- 7. Cottonwood Subdivision Jose Replat  
KPB File 2024-003  
Edge Survey & Design LLC / Jose  
Location: Miracle Avenue & Tundra Rose Circle  
Soldotna Area**

**ITEM #7 - PRELIMINARY PLAT  
COTTONWOOD SUBDIVISION JOSE REPLAT**

<b>KPB File No.</b>	2024-003
<b>Plat Committee Meeting:</b>	February 26, 2024
<b>Applicant / Owner:</b>	Bruce and Jaemi Jose of Soldotna Alaska
<b>Surveyor:</b>	Mark Aimonetti / Edge Survey and Design, LLC
<b>General Location:</b>	Tundra Rose Circle in Kalifornsky area

**Specific Request / Scope of Subdivision:** The proposed plat will combine four lots into one lot totaling 4.319 acres.

### COTTONWOOD SUBDIVISION JOSE REPLAT AND UTILITY EASEMENT VACATION

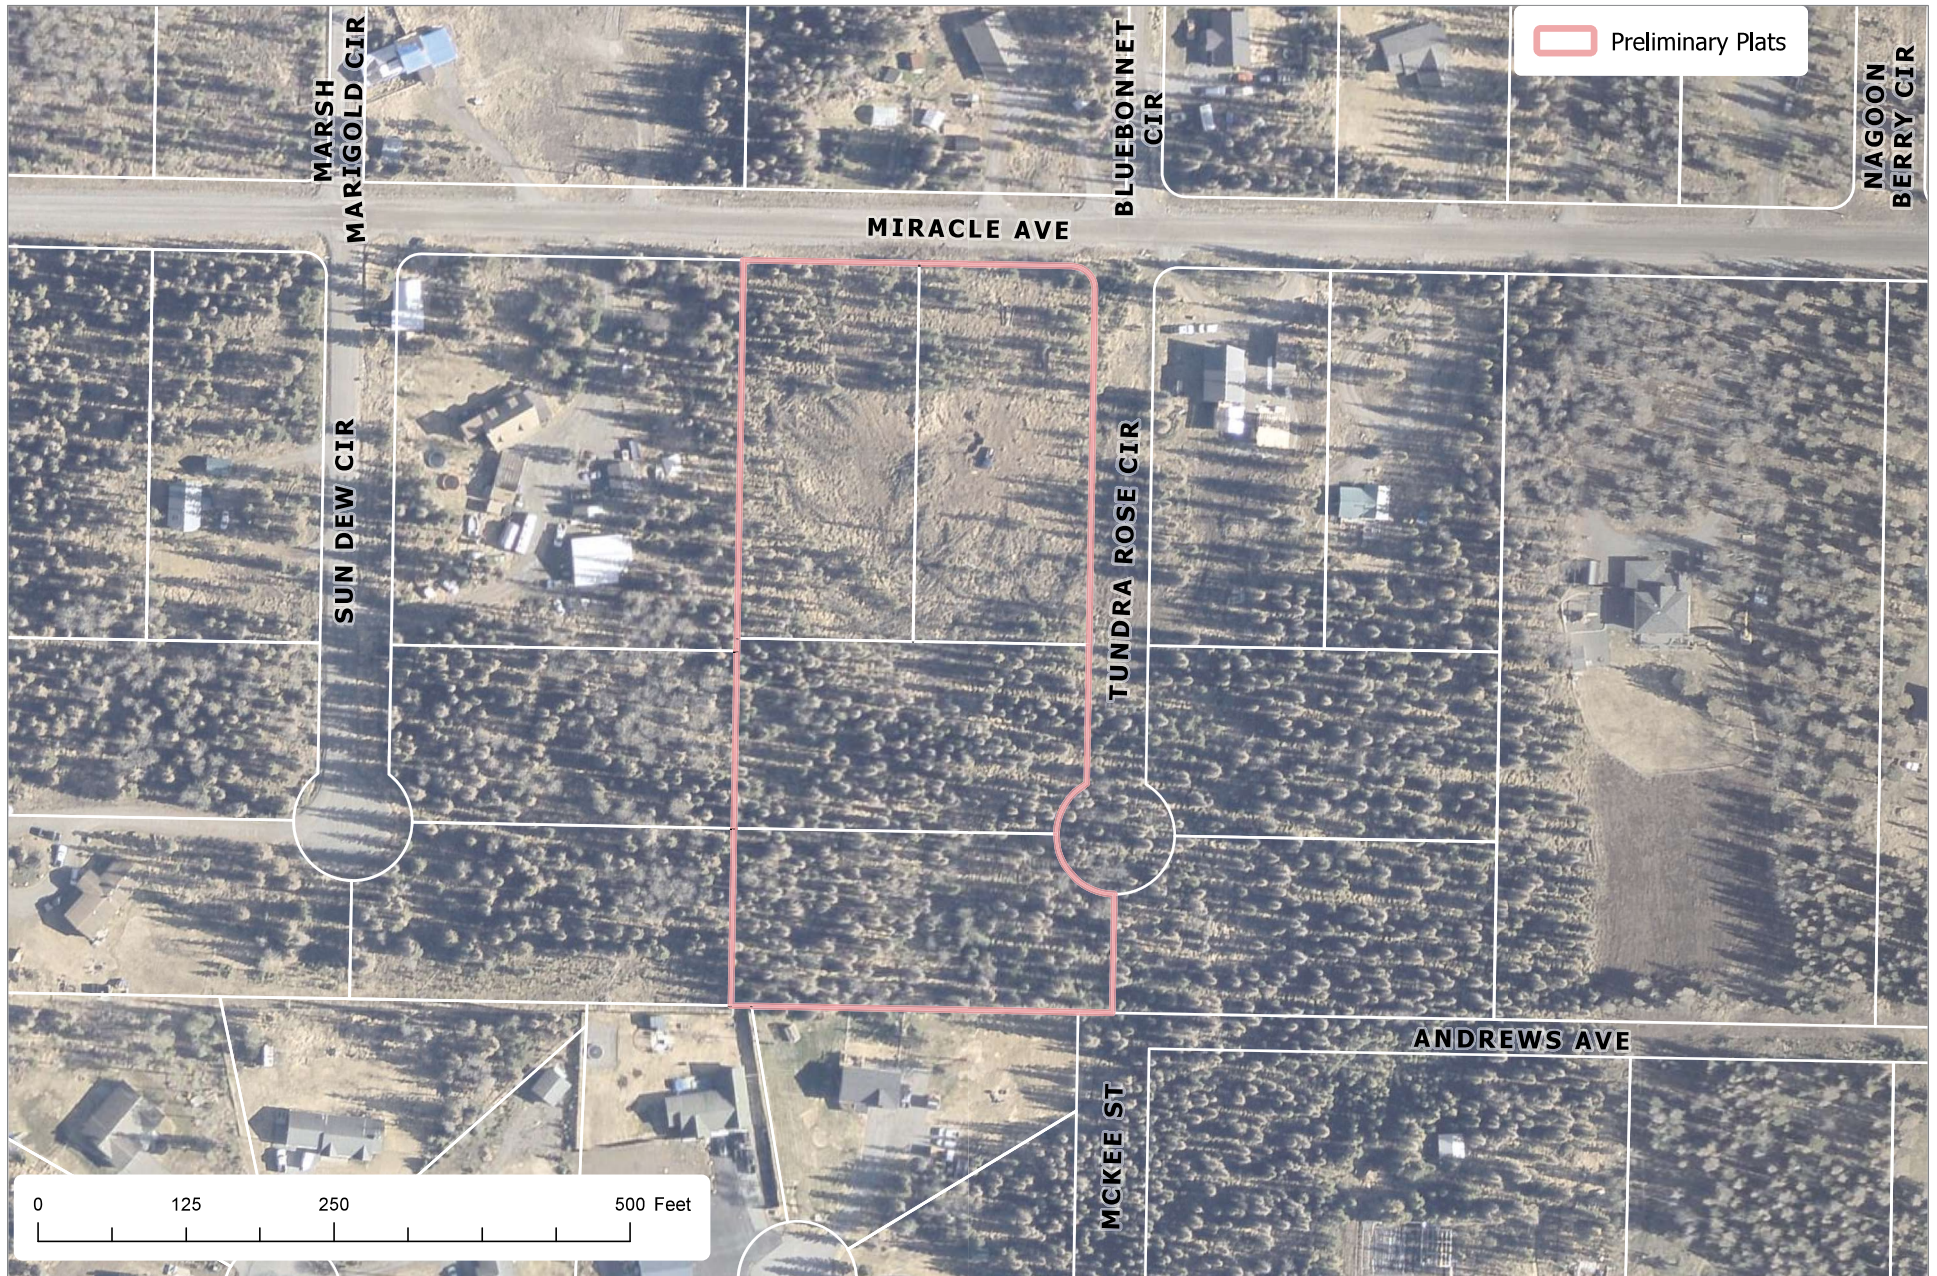
An exception for 20.30.030 Proposed Street layout - requirements is needed as McKee Street from the south should be pushed through to Tundra Rose Circle or a dedication for turning east for Andrews Ave is needed.

An exception for 20.30.210 Streets- Width requirements is also need as Tundra Circle is only 50 feet wide for the existing dedication.

- Correct page listed in plat note 4.
- Add to KPB file no 2024-003.
- Correct date on Plat Approval to February 26, 2024

Label some streets near Miracle Ave, possibly reduce scale to help visibility

Verify easement in book 10 page 317 affects property. Description says It lies 100 feet east of Kalifornsky Rd, please verify.
